UNITED STATES
DEPARTMENT OF THE INTERIOR
BUREAU OF LAND MANAGEMENTFORM APPROVED
OMB NO. 1004-0137
Expires: January 31, 2018**SUNDRY NOTICES AND REPORTS ON WELLS**
Do not use this form for proposals to drill or to re-enter an abandoned well. Use form 3160-3 (APD) for such proposals.5. Lease Serial No.
NMNM58138

7. If Unit or CA/Agreement, Name and/or No.
NMNM871108. Well Name and No.
WEST BISTI COAL 13 COM 19. API Well No.
30-045-28388-00-S110. Field and Pool or Exploratory Area
BASIN FRUITLAND COAL

DJR Operating, LLC requests permission to Plug & Abandon the subject well according to the attached Procedure, Current & Proposed Wellbore Diagram & Reclamation Plan.

BLM FLUID MINERALS Geologic Report

DJR Operating, LLC
Proposed Wellbore Diagram

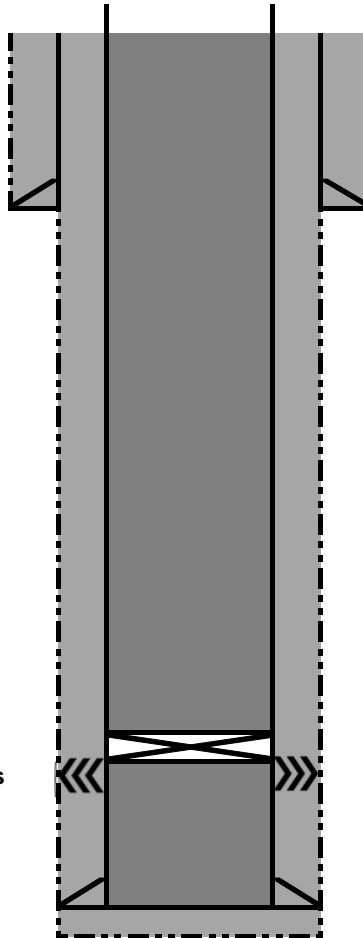
- The proposed plugging plan, if executed as presented, will adequately protect the freshwater sands in this well bore.

- Please ensure that the tops of the Pictured Cliffs and Fruitland formations as well as the entire Ojo Alamo aquifer, identified in this report, are isolated by proper placement of cement plugs. This will protect the freshwater sands in this well bore.
